# FINAL DRAINAGE PLAN AND REPORT

## HOT MIX HEIGHTS DEVELOPMENT

### AMENDED PLAT BARBARICK SUBDIVIISON

PCD File #  
PPR2332

SFB P2-7

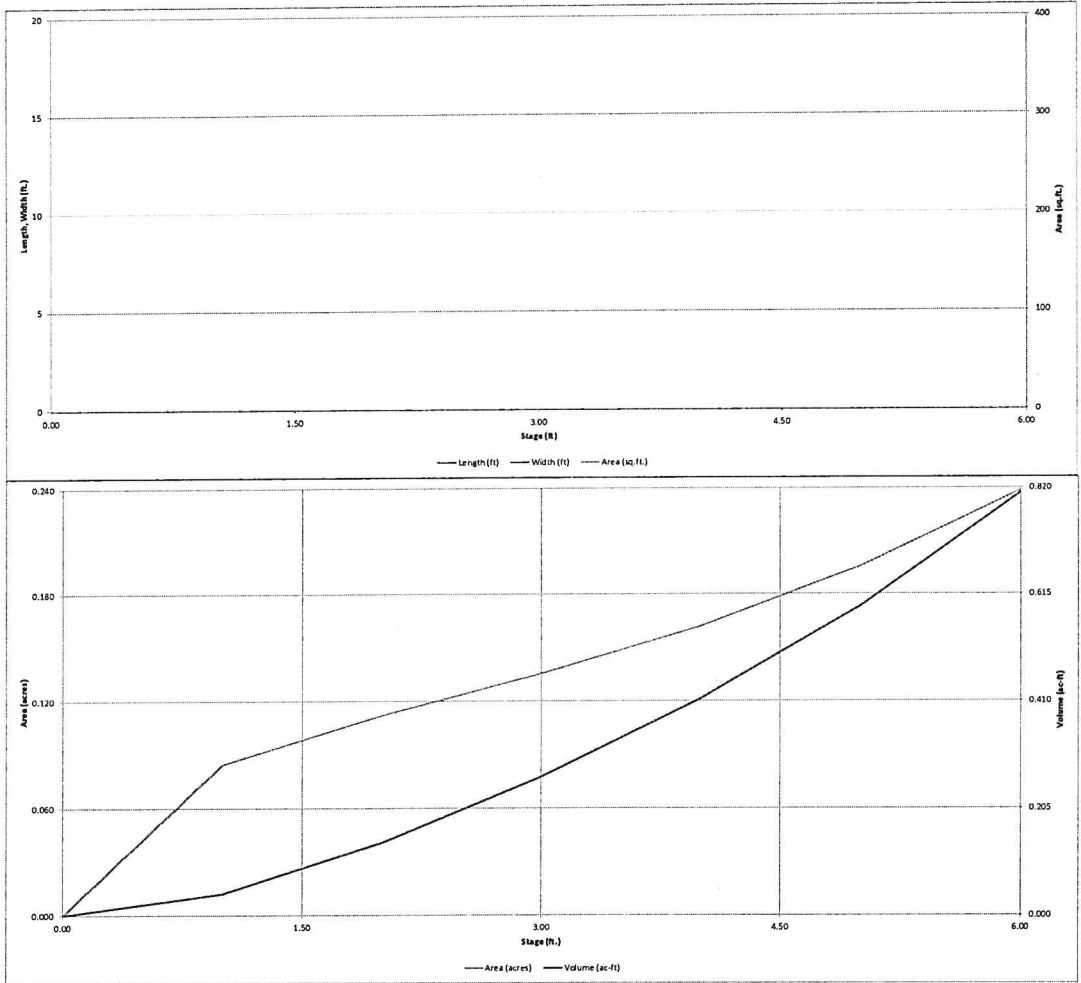
The SFB calcs from the Matrix report (PDF pg 41 of 76) show 9.7ft of depth in this column. I think the EDB and SFB stage inputs got swapped, since you show 10ft for the depth of the EDB.

As an aside: I'm not sure how Matrix got a depth of 9.7ft for the SFB when it (and the EDB for that matter) is shown on the CD's as closer to 5ft deep. Look into this and make your SFB and EDB depth inputs reflect the current as-built conditions.

Fill this in to match what's shown on PDF pg 42 of 76 of the Matrix report: 1.00 and 1.27, respectively.

I'm concerned that the underdrain orifice was never installed because a detail for it was not provided on the original CD's from Matrix. There is a standard detail on sheet SD04 (pg 12 of 16) that calls out the need for a orifice plate, but no detail specifying the size, installation details, or location.

#### Routed Hydrograph Results

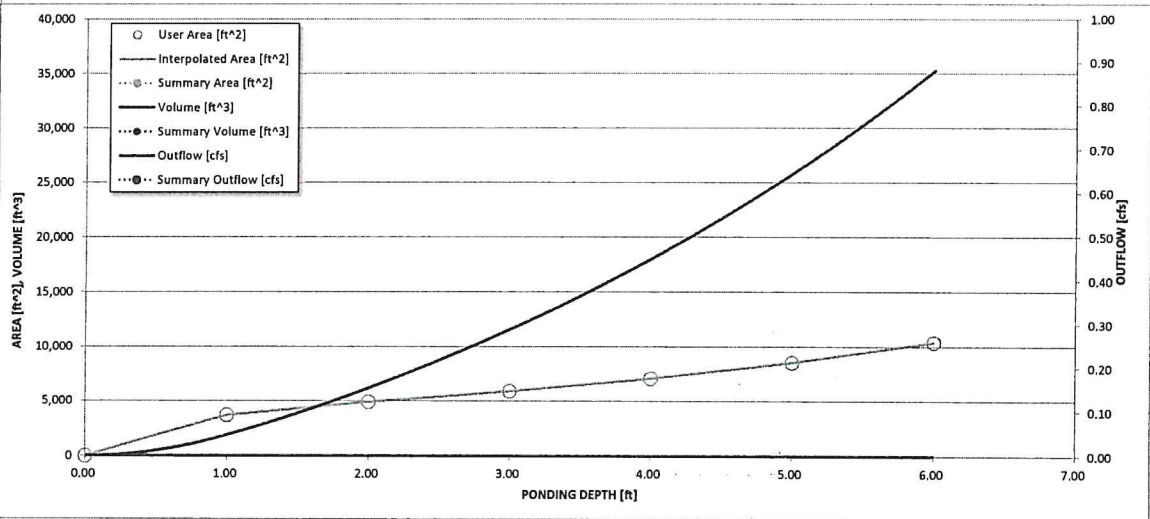
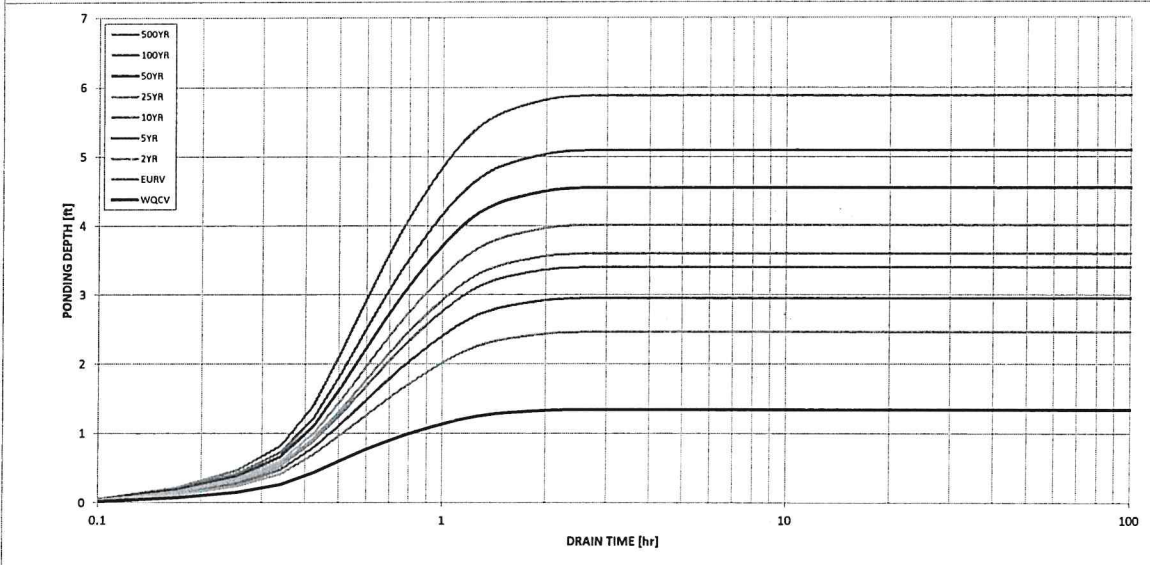
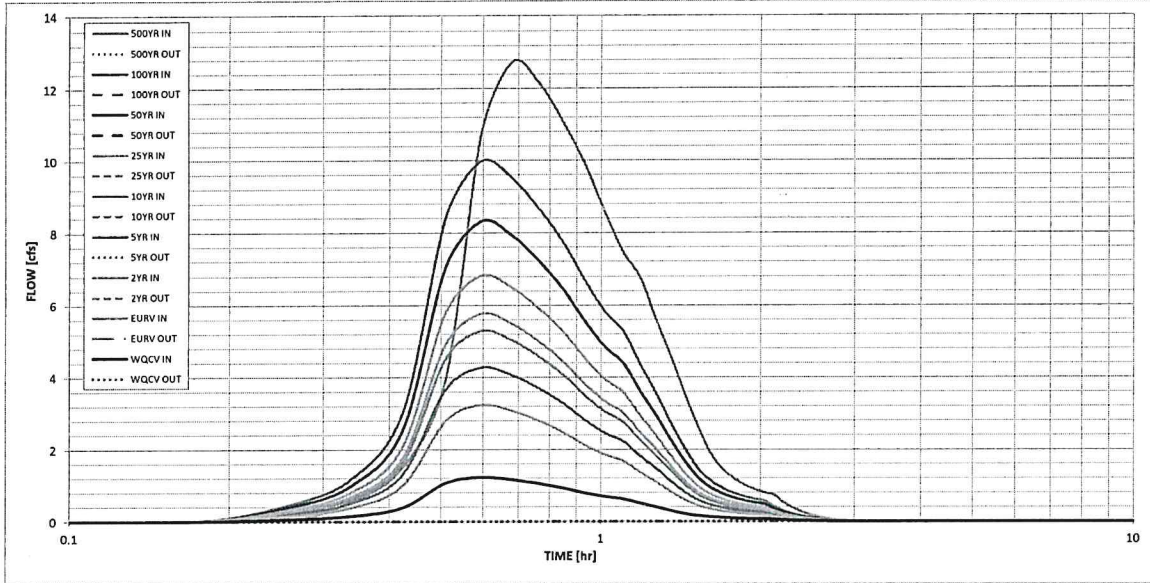
With the increase in flowrates from the Matrix design to current field conditions, we will want to see that this row is still less than or equal to 1.0 for all columns.

EPC will need to review this table with the next submittal once sufficient inputs above are completed such that this table populates.

The original Matrix design (PDF pg 39 of 76 of that report) shows the make stage at 6.5ft. Where did this extra 3.5ft come from? On your SDP drawing, I'm still only seeing ~6ft via contours 7019 to 7025. Revise these inputs to match conditions of pond.

### Routed Hydrograph Results

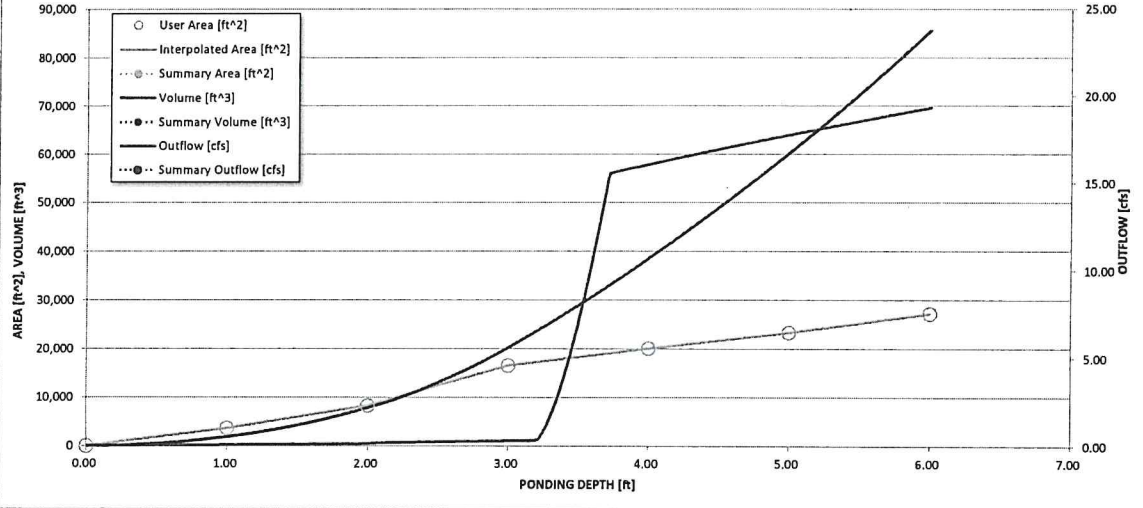
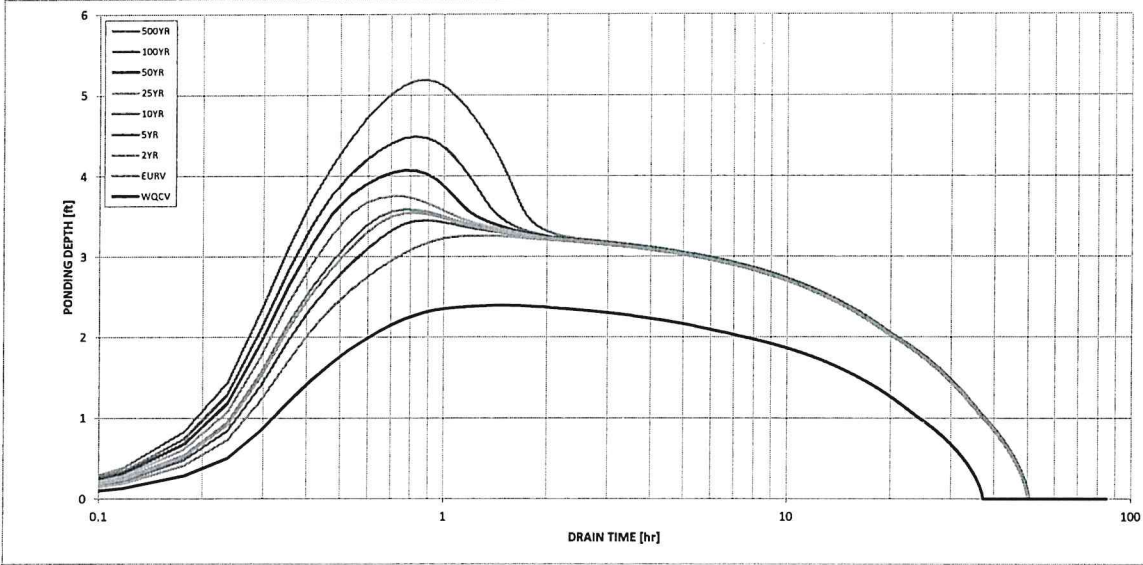
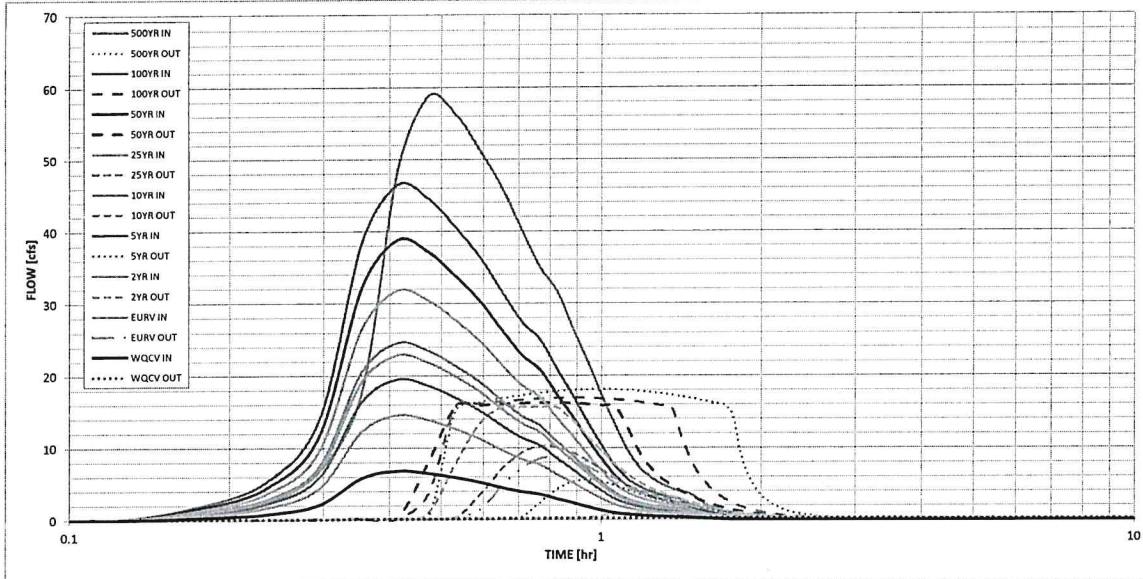
All of these values should be less than or equal to 1.0. If not, the report text above must discuss the suitability of the outfall to handle the extra flows (capacity and for erosion). Investigate why they are currently greater than 1.0 and revise text and/or calcs as needed. Note: this output table was not included in the Matrix report (only inputs shown on PDF page 39 of 76 of that report).

Basin Map - from the FDR

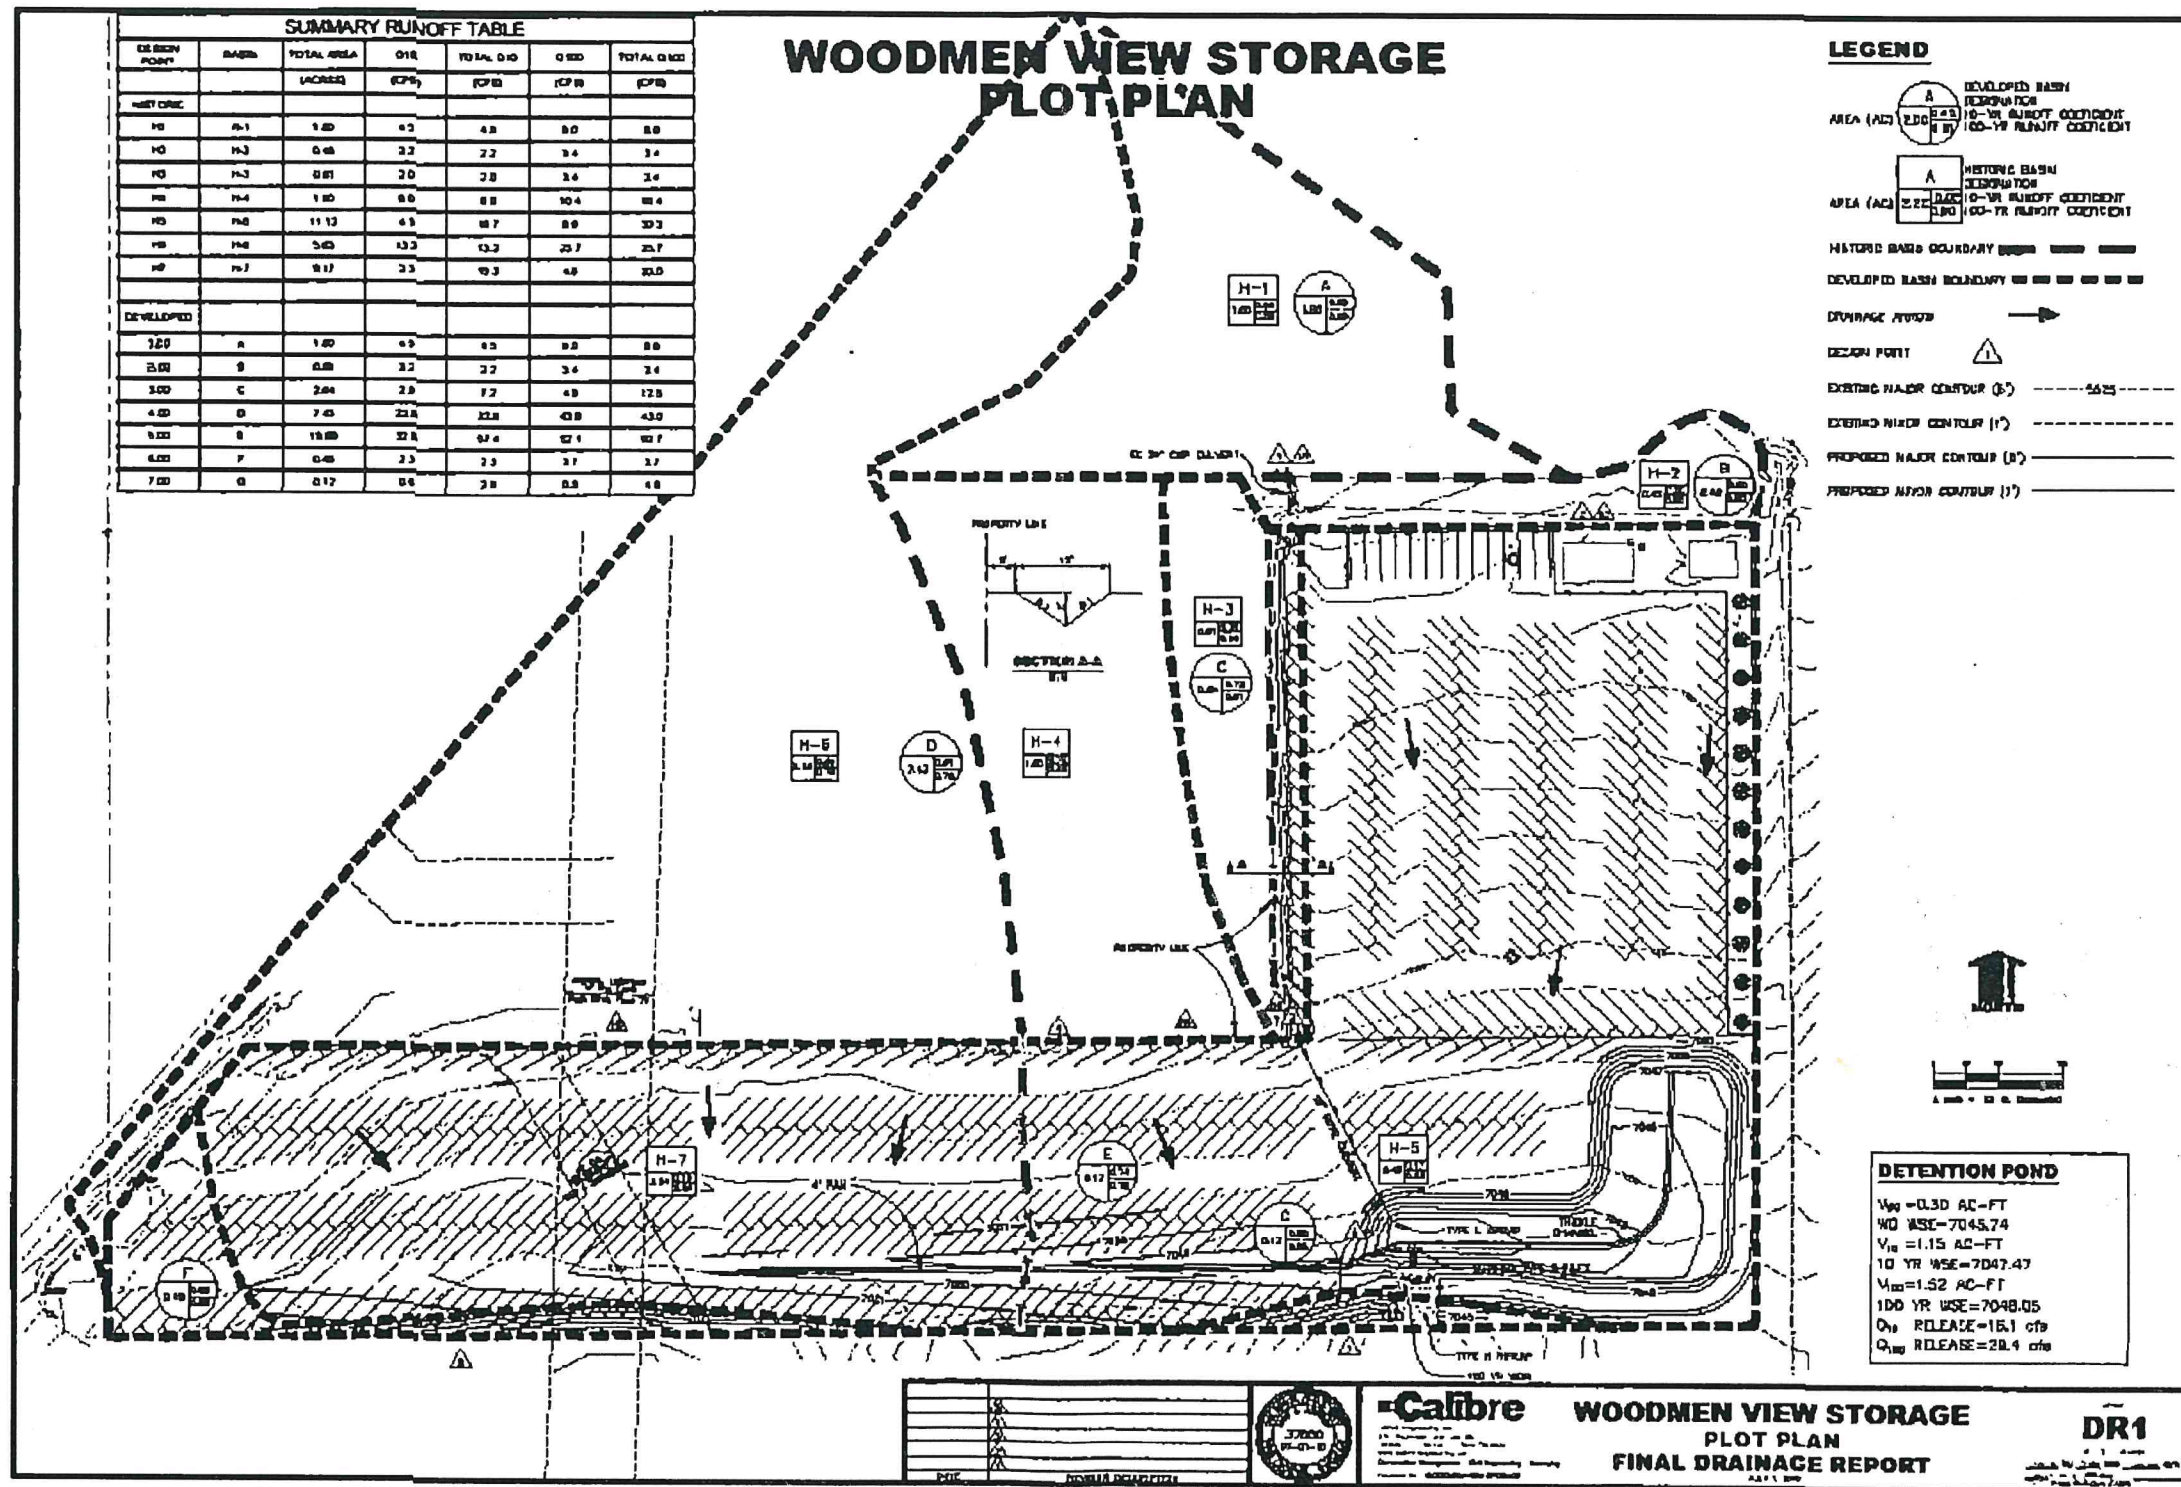
- Note: Drainage concerns include existing stormwater quality and quantity management, which involves more than Lot 1 and this submittal. With residential subdivisions being constructed and under review to the east and south, these concerns need to be addressed. Staff would like to arrange a site visit with the project engineers to verify and discuss concerns.

- The Final Drainage Plan and Report dated December 18, 2020 needs to be revised to address the following:
  - The MHFD calculation sheets need to be completed and volumes and elevations verified. There appear to be volume and elevation discrepancies between the report submitted and previously approved plans, reports and an as-built letter dated January 16, 2017. Staff request that the design engineers coordinate with each other to verify calculations prior to resubmittal of the revised report to EPC.

- West Sand Filter Basin (Lot 2, also serving Lot 1):
    - The SFB appears to need maintenance and possibly reconstruction based on aerial photos and the surveyed contours shown on the drainage plan being different than previous plans.

- Infiltrometer tests may be necessary on the SFB to verify spreadsheet modeling input.
    - It appears that the ponding/headwater area for the culverts to the southwest needs maintenance.

- The increase in embankment height proposed with this submittal raises the question of how the existing trees in this location will be handled; please address.
